Groundwater Transfer Review Summary Form

Transfer/PA # T- 14403

Application: T-14403

Applicant Name: Stanfield Hutterian Farm C/O Herb Stahl

Figure 1. Map of Authorized POA, Proposed APOA, and nearby wells listed by aquifer system.

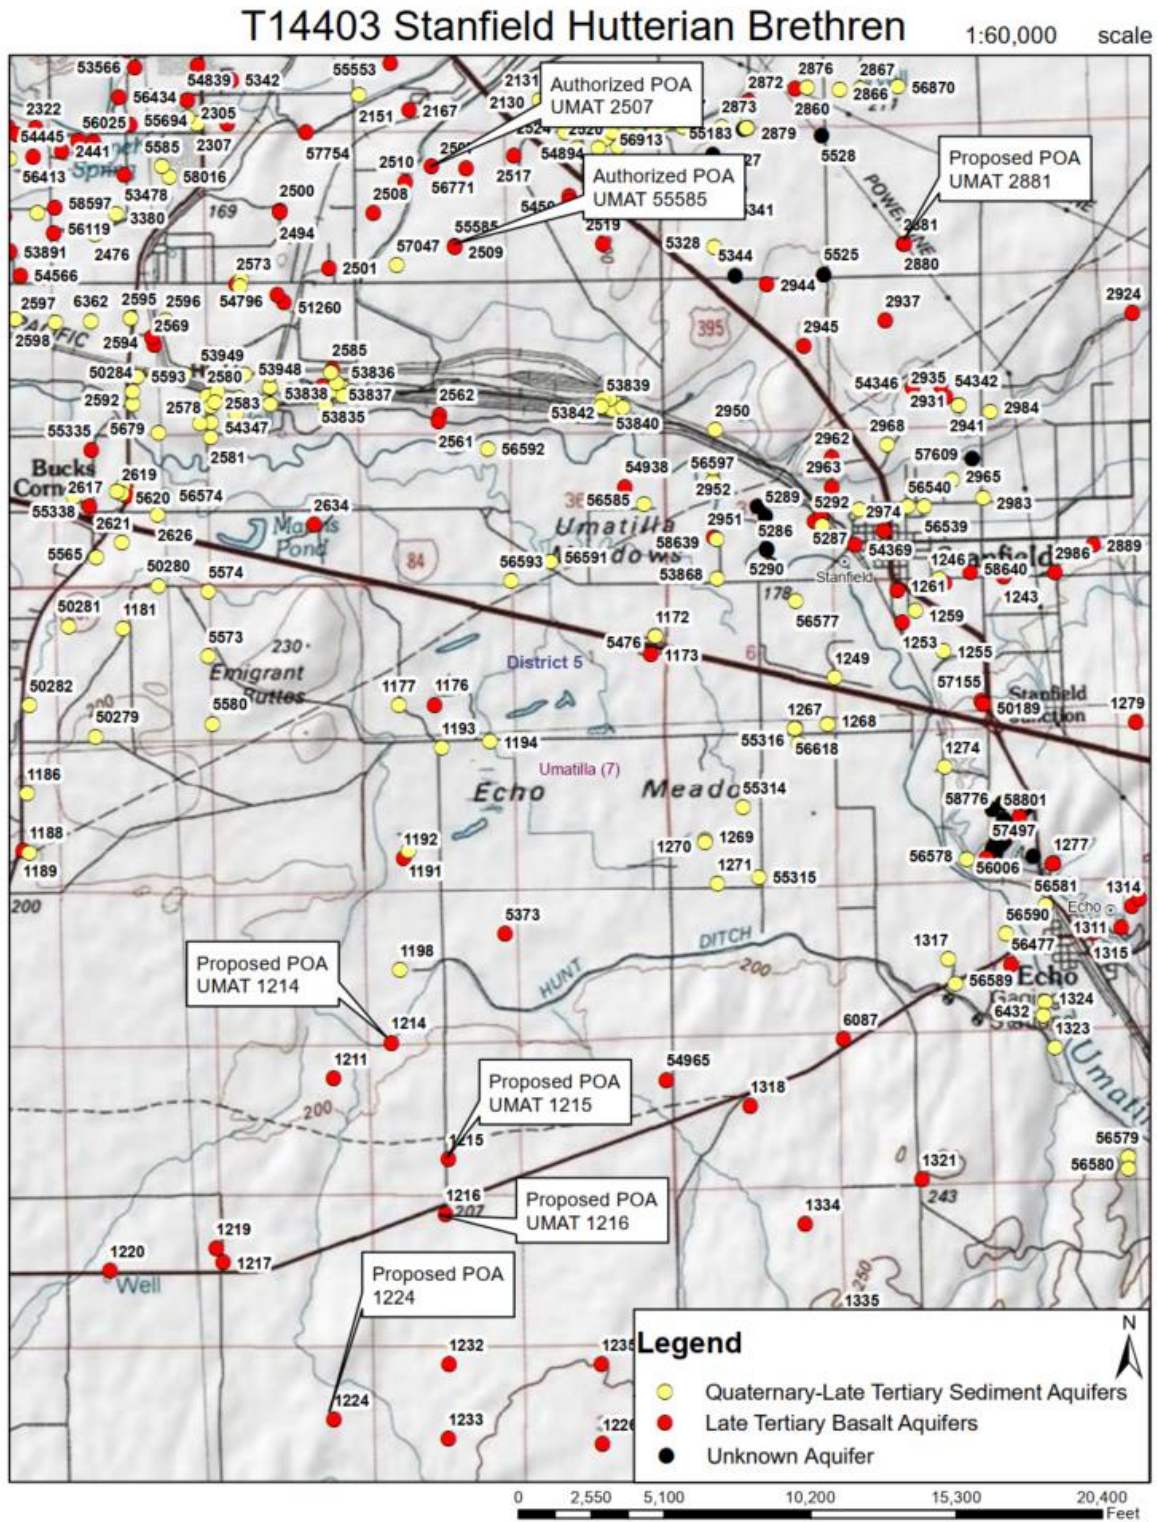
1. Basic description of the changes proposed in this transfer: The applicant proposes to change the place of use for Certificate 97371 and Certificate 87368. The applicant also proposes additional POAs for Certificate 97371 and Certificate 87368. The temporary transfer for Certificate 87368 would result in supplemental use to Certificates 83083 and 75554. The temporary transfer for Certificate 97371 would result in supplemental use to Certificates 83083, 75554 and 96886. The authorized and proposed POAs associated with these water rights are displayed in Table 1 and Figure 1.

2. Will the proposed POA develop the same aquifer (source) as the existing authorized POA?
☒ Yes ☐ No Comments: All of the authorized From-POAs and the proposed To-POAs are all developed in basalt in the Stage Gulch Critical Groundwater Subarea A.

Figure 2. Estimated interference drawdown at the nearest existing water right POD (UMAT 1233) from pumping at the Proposed APOA UMAT 1224. Model inputs for aquifer properties referenced from aquifer test data reported in Zwart 1990.

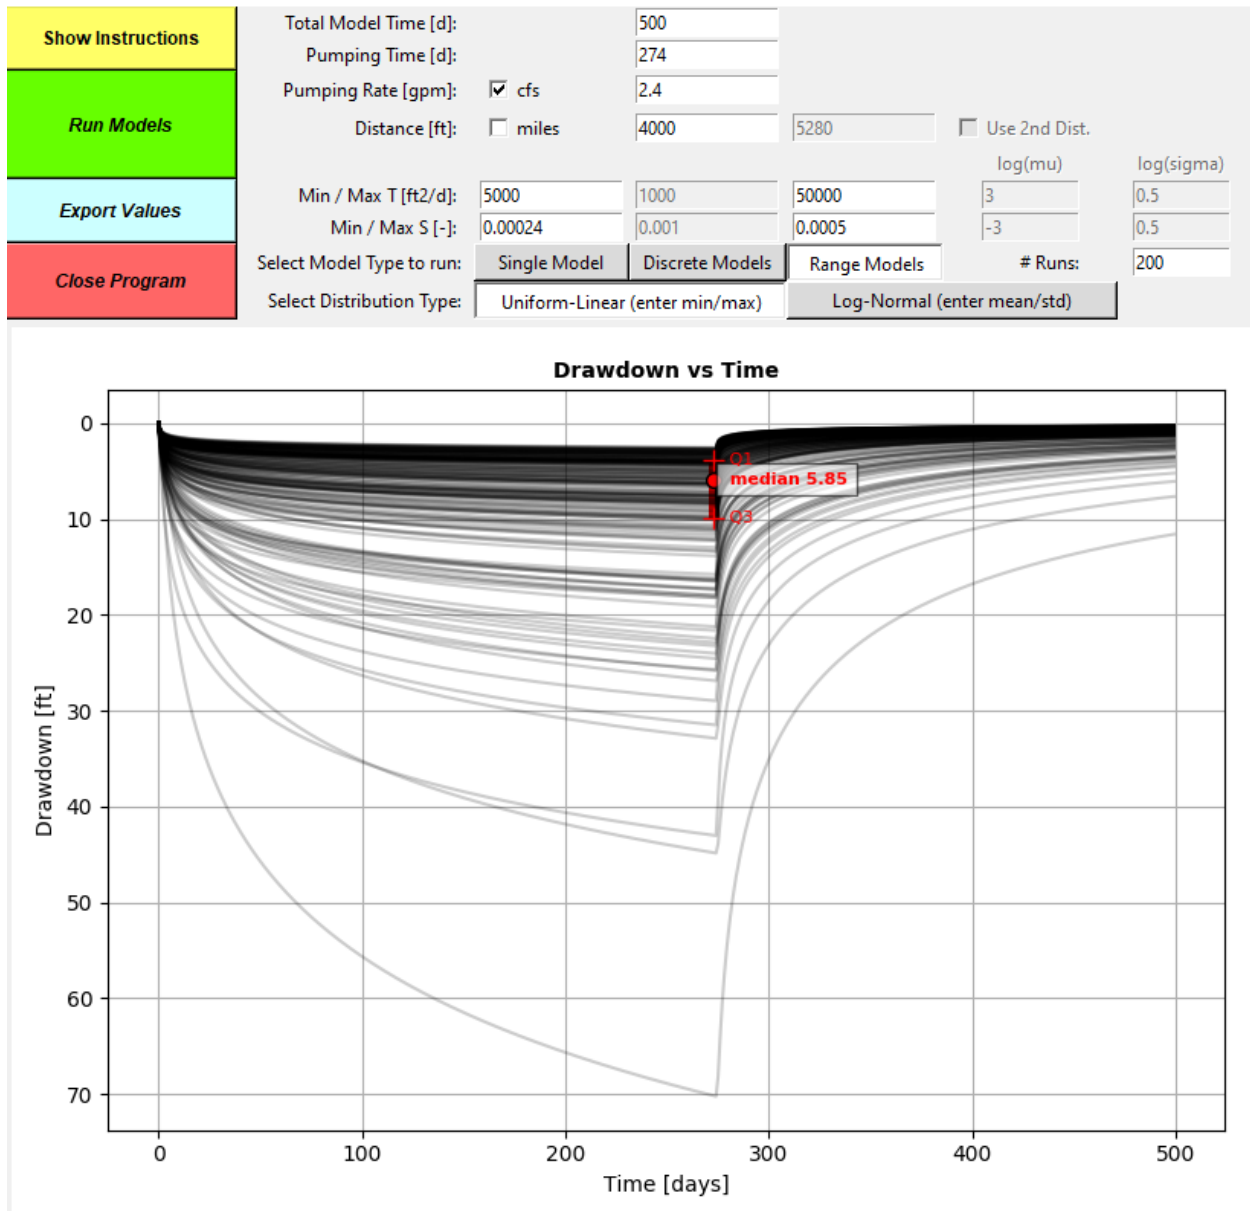
4. a) Will this proposed change, at its maximum allowed rate of use, likely result in an increase in interference with **another ground water right**?
☒ Yes ☐ No Comments: Pumping at the maximum authorized rate from the proposed APOA UMAT 1224 (2.4 cfs) will likely result in 5.9 feet of additional interference with nearest existing groundwater right (UMAT 1233; Cert. 80652, Cert. 61534, and Cert. 95542) (Figure 2). Pumping at the maximum proposed rate from UMAT 2881 (0.49 cfs) will result in approximately 1.0 feet of additional interference at the nearest existing groundwater right (UMAT 2937, Certificate 76119) (Figure 3).

b) If yes, would this proposed change, at its maximum allowed rate of use, likely result in another groundwater right not receiving the water to which it is legally entitled?
☐ Yes ☒ No If yes, explain: _____
